MAZDA N4AEL SOFT OR FLARED SHIFTS WHEN WARM

COMPLAINT: Shifts seem fine when cold, but become increasingly drawn out as the transmission warms up

Figure 1

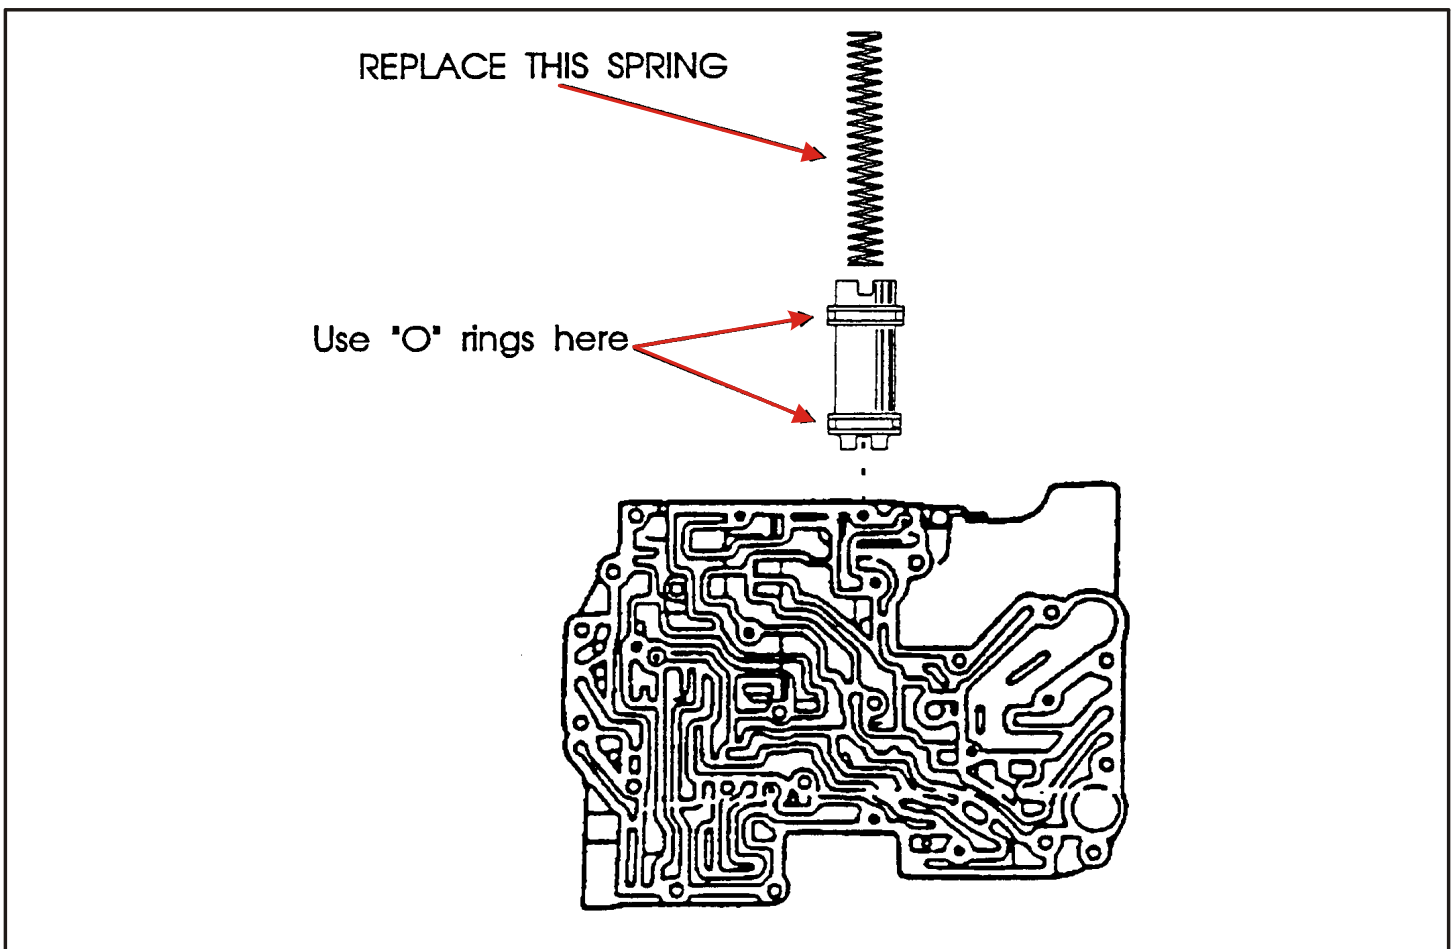
CAUSE: Valve body calibration problems related to fluid temperature.

2. Replace the 1-2 accumulator piston teflon rings with suitable "O" rings. Replace the 1-2 accumulator spring with a stronger spring (A 700-R4 throttle plunger spring is sufficient if it is shimmed 1/4 in. on the piston side). SEE FIGURE 1.
